Access Compliance Report Public Rights-of-Way (Curb Ramps)

Intersection ID: 14213	Main Street: CENTRAL_AV	Cross Street: ROSEHAVEN_DR	Location: SW
ADA ID: 8FFB8420DF55	Ramp Type: Para	Initial Pass/Fail: Fail	Overall Compliance: No Severity Score: 12.5

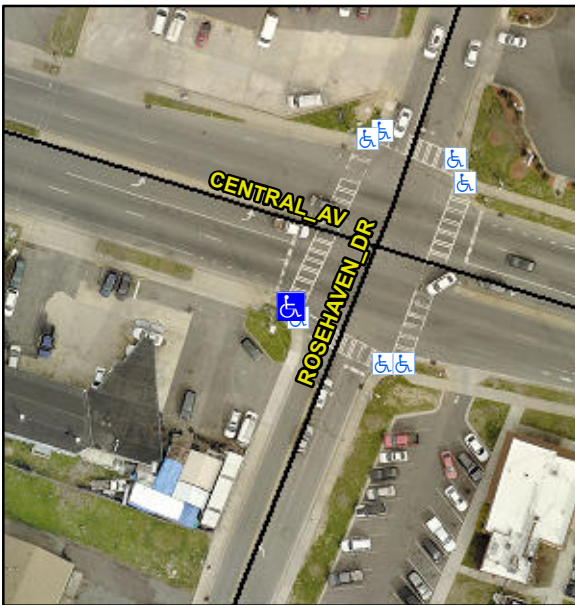
R304.3.2

Compliance	Description	Data	Compliance	Description	Data
N/A	Ramp Length LT (in)	26.5	N/A	Ramp Length RT (in)	52.5
Yes	Ramp Width LT (in)	71.0	Yes	Ramp Width RT (in)	71.0
Yes	Ramp Slope LT (%)	5.0	No	Ramp Slope RT (%)	10.6
Yes	Ramp XSlope LT (%)	1.0	Yes	Ramp XSlope RT (%)	1.7
N/A	Landing Length (in)	N/A	N/A	DWS Provided?	N/A
N/A	Landing Width (in)	N/A	N/A	DWS Contrast?	N/A
N/A	Landing Slope (%)	N/A	N/A	DWS Length (in)	N/A
N/A	Landing X Slope (%)	N/A	N/A	DWS Full Width?	N/A
N/A	Landing Curb? (Y/N)	N/A	N/A	DWS Offset (in)	N/A
N/A	Shared Landing?	N/A			
N/A	Gutter Ponding?	N/A	N/A	Gutter Slope (%)	N/A
N/A	Gutter Lip Ht (in)	N/A	N/A	Gutter X Slope (%)	N/A
N/A	Painted X Walk1?	Yes	N/A	Painted X Walk2?	N/A
	X Walk 1 Direction	To N		X Walk 2 Direction	N/A
N/A	X Walk 1 Width (in)	108.0	N/A	X Walk 2 Width (in)	N/A
	X Walk 1 Slope (%)	0.5		X Walk 2 Slope (%)	N/A
	X Walk 1 X Slope (%)	3.1		X Walk 2 X Slope (%)	N/A
N/A	Ramp inside XWalk1?	Yes	N/A	Ramp inside XWalk2?	N/A

Remove & Replace Entire Ramp.
